[Docket No. 97-SW-32-AD; Amendment 39-10520; AD 97-18-11]

Airworthiness Directives; Bell Helicopter Textron (Bell) Model 204B, 205A, and 205A-1 Helicopters

AD 97-18-11 Bell Helicopter Textron: Amendment 39-10520. Docket No. 97-SW-32-AD.

Fig. 1

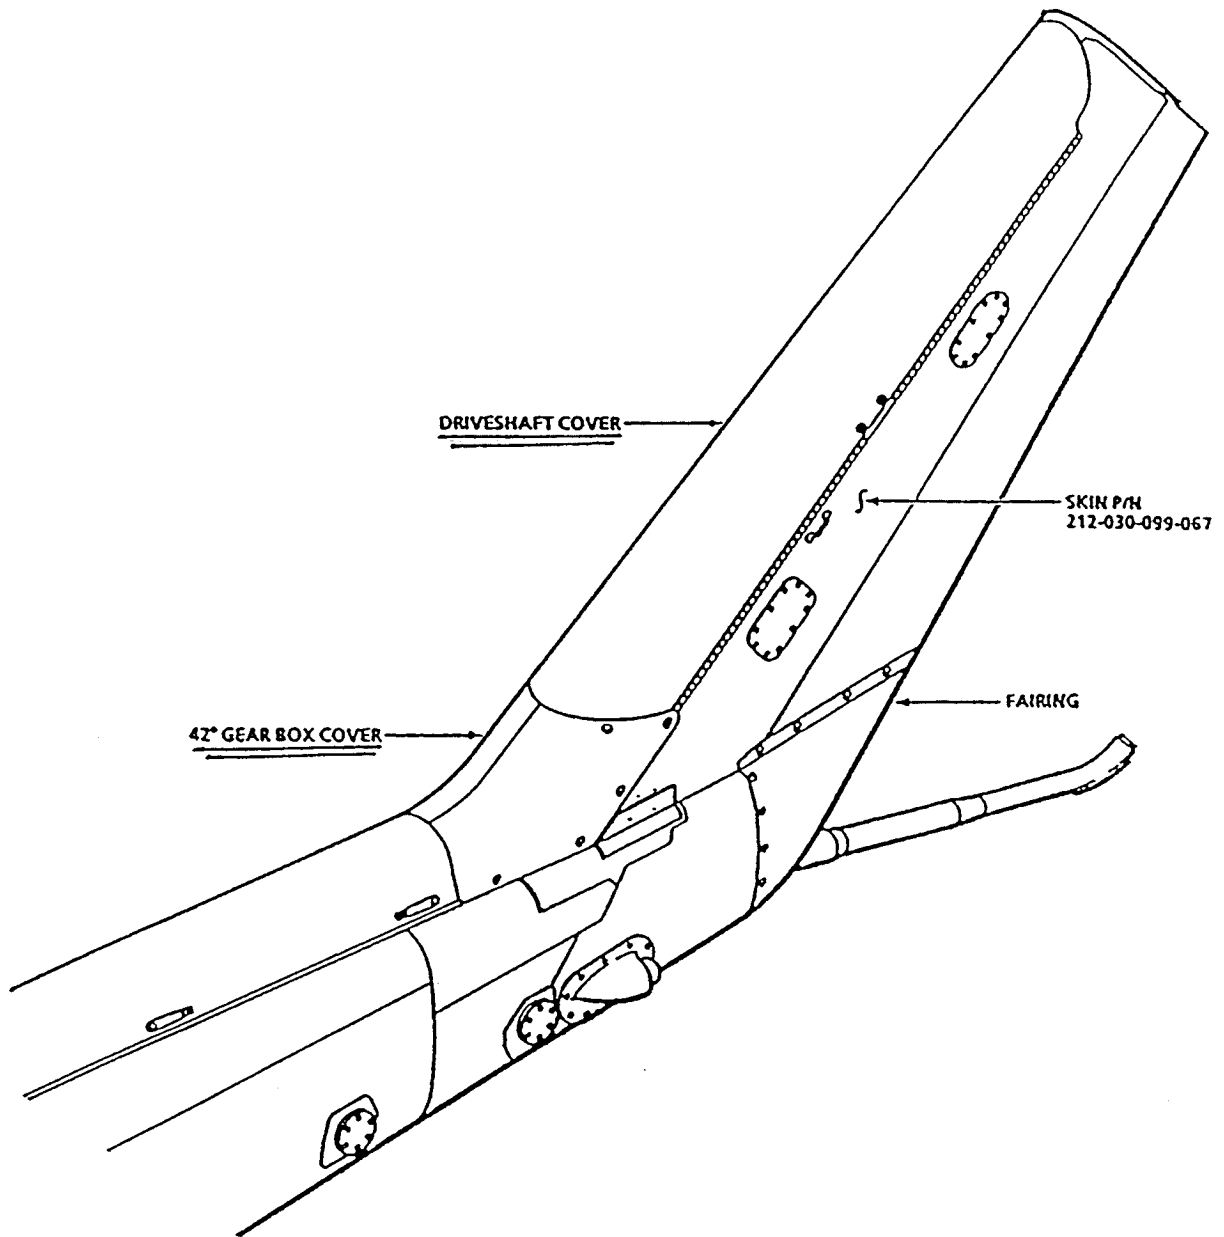
(1) Remove the 42° gearbox cover and open the drive shaft cover on the vertical fin spar assembly (see Figure 1).

(ii) Remove the 42° gearbox cover and open the drive shaft cover on the vertical fin (see Figure 1).

(1) Remove the 42° gearbox cover and open the drive shaft cover on the vertical fin spar assembly (see Figure 1).

(ii) Remove the 42° gearbox cover and open the drive shaft cover on the vertical fin spar (see Figure 1).

FIG. 2 DETAIL - A -
204B CONFIGURATION

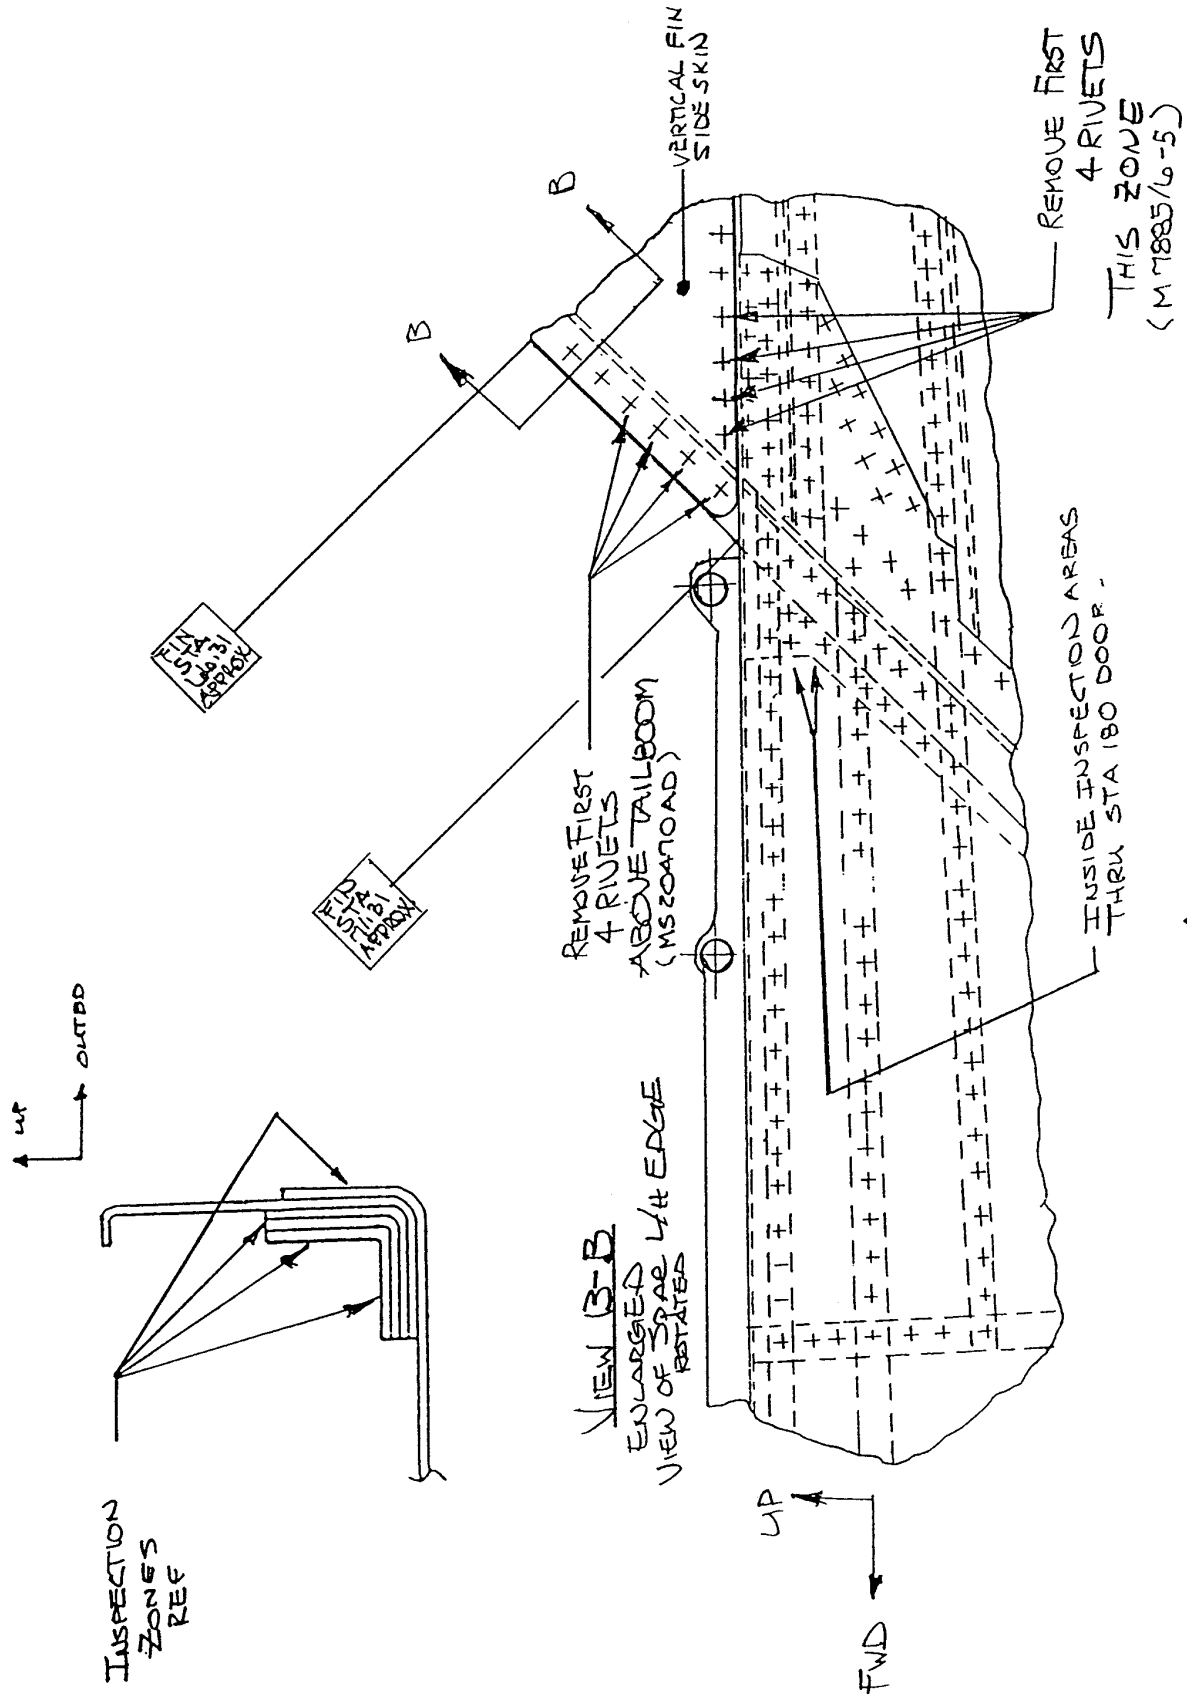
(i) Remove the first four rivets from the vertical fin spar located at the bottom of the vertical fin spar left-hand side at the tailboom and vertical fin spar junction, and the first four rivets aft of the junction along the lower edge of the vertical fin spar skin (skin) as shown (see Figure 2). CAUTION: Extreme care must be taken when drilling and removing rivets from the side of vertical fin spar to ensure the vertical fin spar assembly is not damaged.

FIG. 3
VIEW LOOKING INBOARD
LEFT SIDE

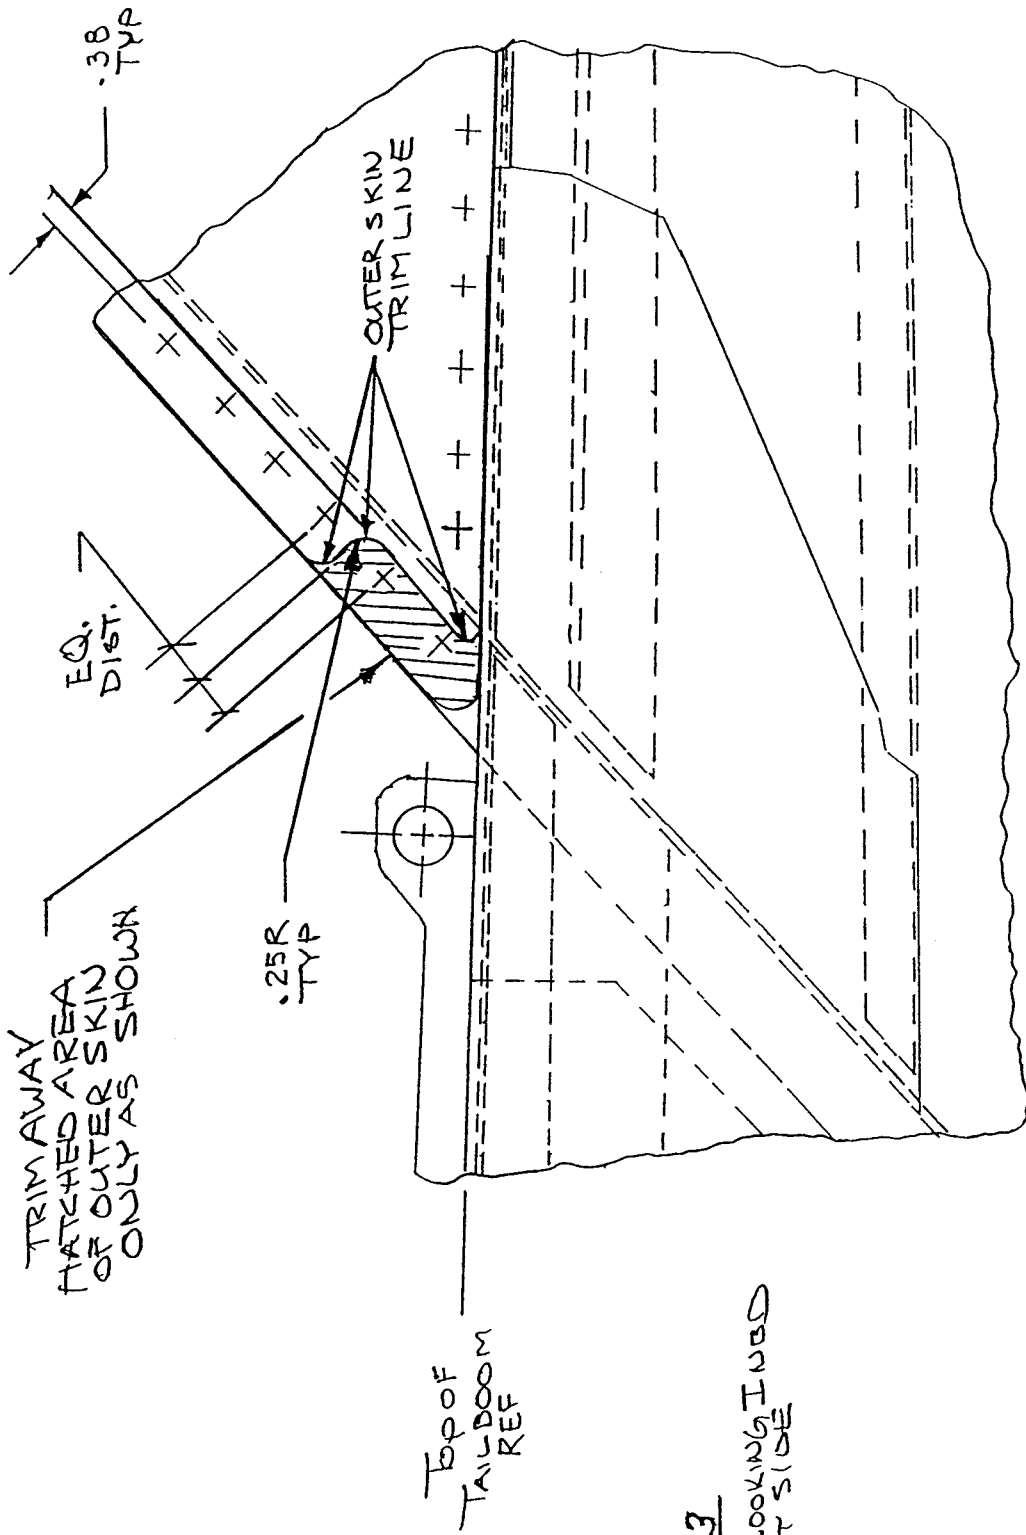
(ii) Trim the vertical fin spar left-hand skin using extreme care to not damage the vertical fin spar assembly (see Figure 3).

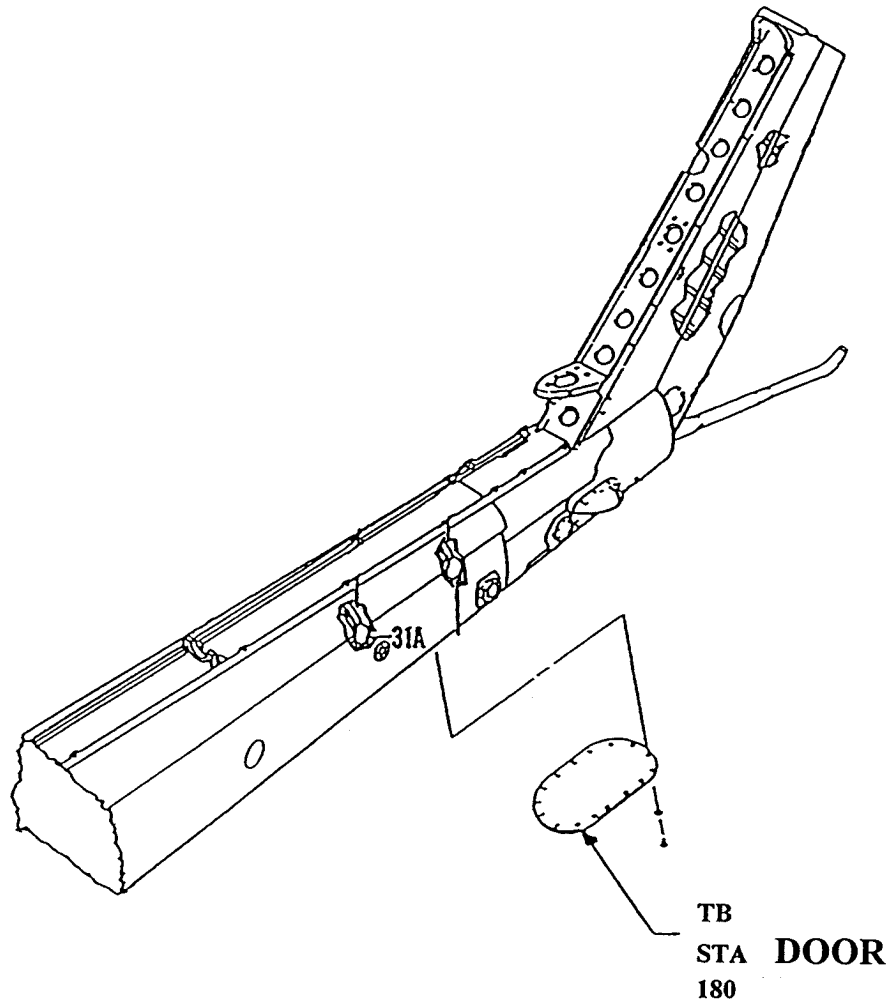
(iii) Through the lower aft tailboom inspection door, using a bright light and an inspection mirror, inspect the vertical fin spar assembly adjacent to the tailboom top skin on the forward side, paying special attention to the left-hand edge and the adjacent surfaces (see Figure 5).

(iv) In a ventilated work area, clean all surfaces to be inspected with a cloth dampened with aliphatic naphtha or an equivalent cleaning solvent. Using a bright light and a 10x magnifying glass, inspect the vertical fin spar assembly adjacent to the tailboom top-skin on the in-board and out-board sides, the vertical edge, and the two open rivet holes. Using a bright light and a mirror, inspect the aft side of the vertical fin spar in the same area. Special attention must be given to the left-hand edge of the vertical fin spar and any adjacent surfaces between fin stations 66.31 and 71.31 (see Figure 5).

(ii) Remove the first four rivets from the vertical fin spar, located at the bottom of the vertical fin spar left-hand side at the tailboom and vertical fin spar junction as shown (see Figure 5). CAUTION: Extreme care must be taken when drilling and removing rivets from the side of vertical fin spar to ensure the vertical fin spar assembly is not damaged.

(vi) Reinstall the clip and radius block with M 7885/6-5 rivets (see Figure 5).

(iii) Through the lower aft tailboom inspection door, using a bright light and an inspection mirror, inspect the vertical fin spar assembly adjacent to the tailboom top skin on the forward side, paying special attention to the left-hand edge and the adjacent surfaces (see Figure 5).

(iv) In a ventilated work area, clean all surfaces to be inspected with a cloth dampened with aliphatic naphtha or an equivalent cleaning solvent. Using a bright light and a 10x magnifying glass, inspect the vertical fin spar assembly adjacent to the tailboom top-skin on the in-board and out-board sides, the vertical edge and the two open rivet holes. Using a bright light and a mirror, inspect the aft side of the vertical fin spar in the same area. Special attention must be given to the left-hand edge of the vertical fin spar and any adjacent surfaces between fin stations 66.31 and 71.31 (see Figure 5).

Fig. 4

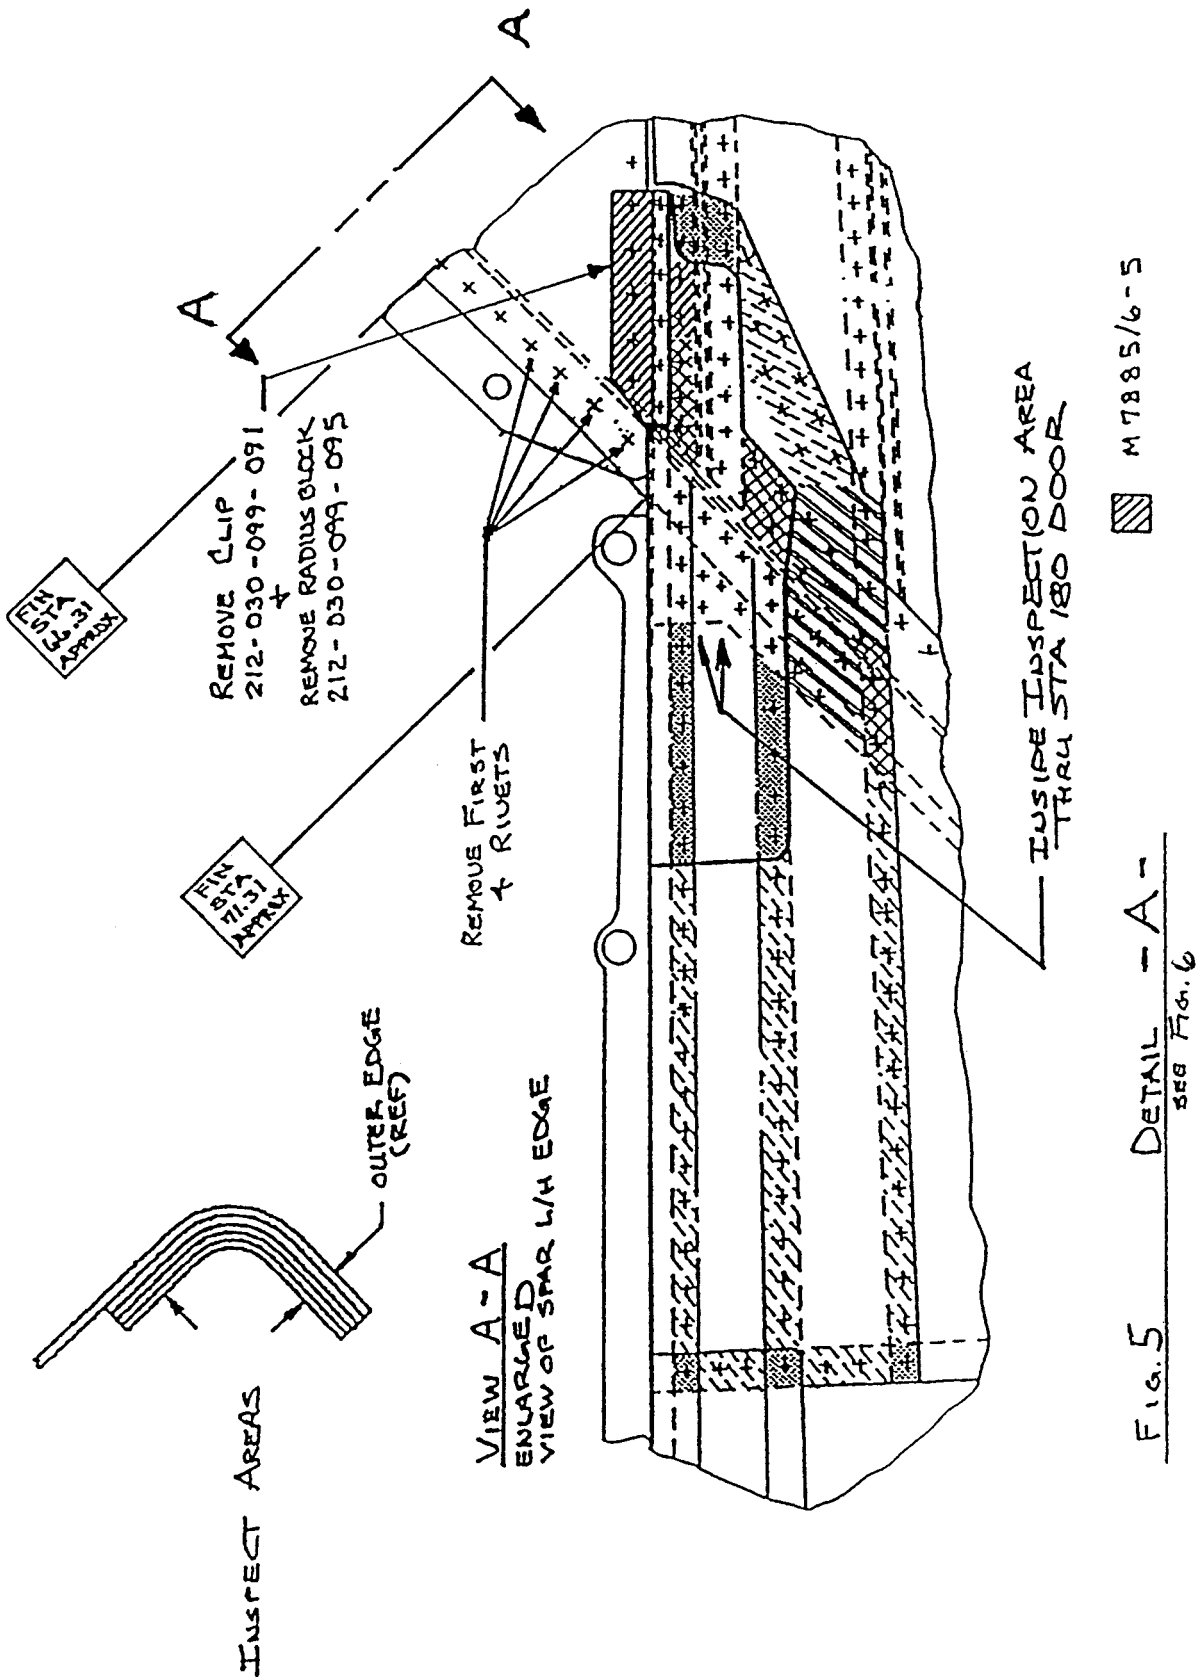
(i) Remove the lower aft tailboom inspection door, located at tailboom station 180 (see Figure 4).

(i) Remove the lower aft tailboom inspection door, located at tailboom station 180 (see Figure 4).

FIG 6 VIEW LOOKING INGD
L/H SIDE

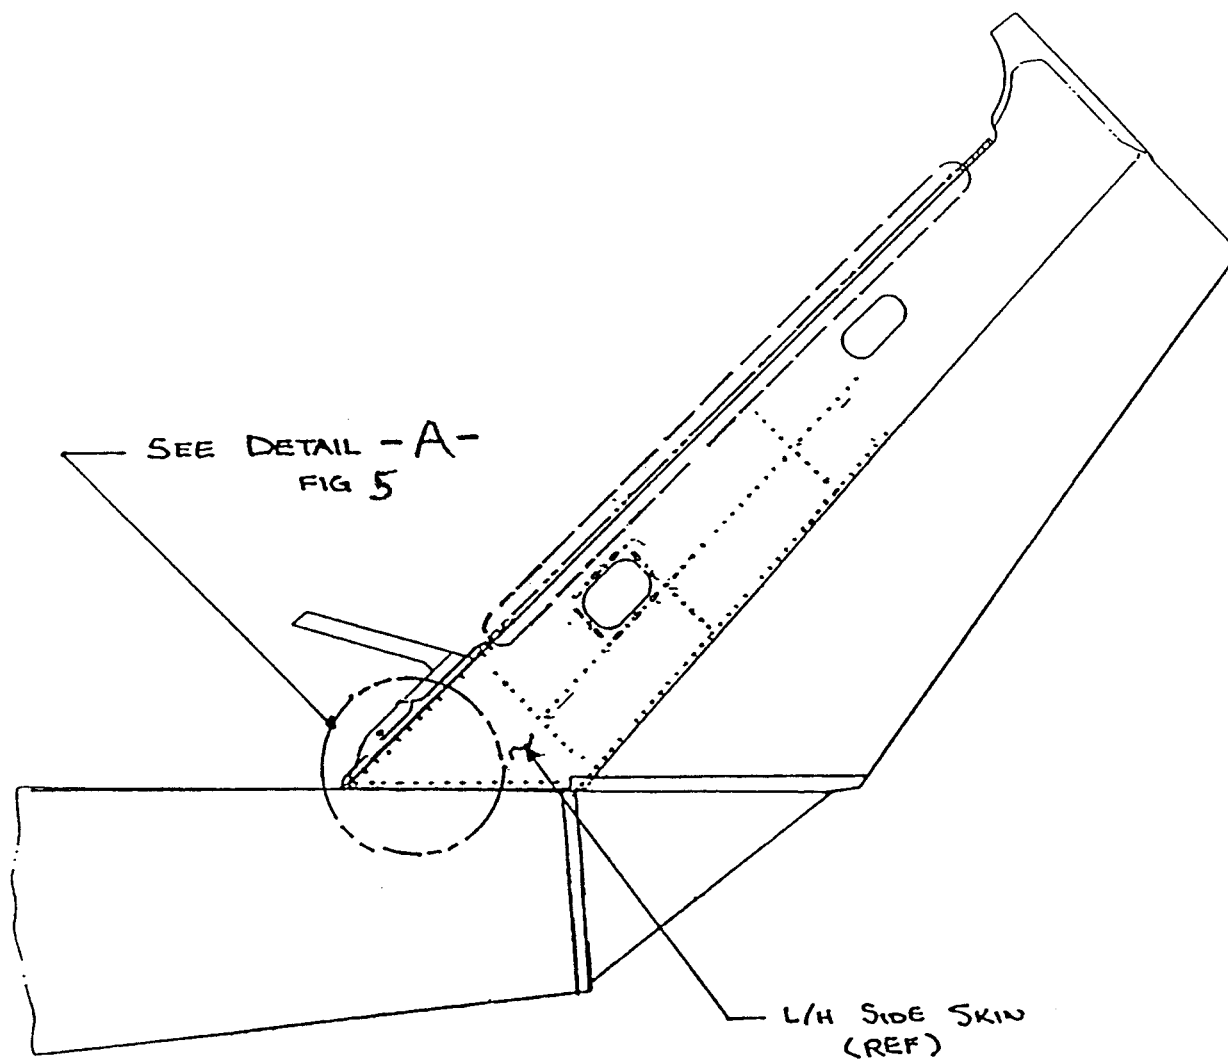
(v) Reinstall the vertical fin spar skin lower edge rivets using M 7885/6-5 rivets (see Figure 6).

(i) Remove the clip, P/N 212-030-099-091, and the radius block, P/N 212-030-099-095, (see Figures 5 and 6).
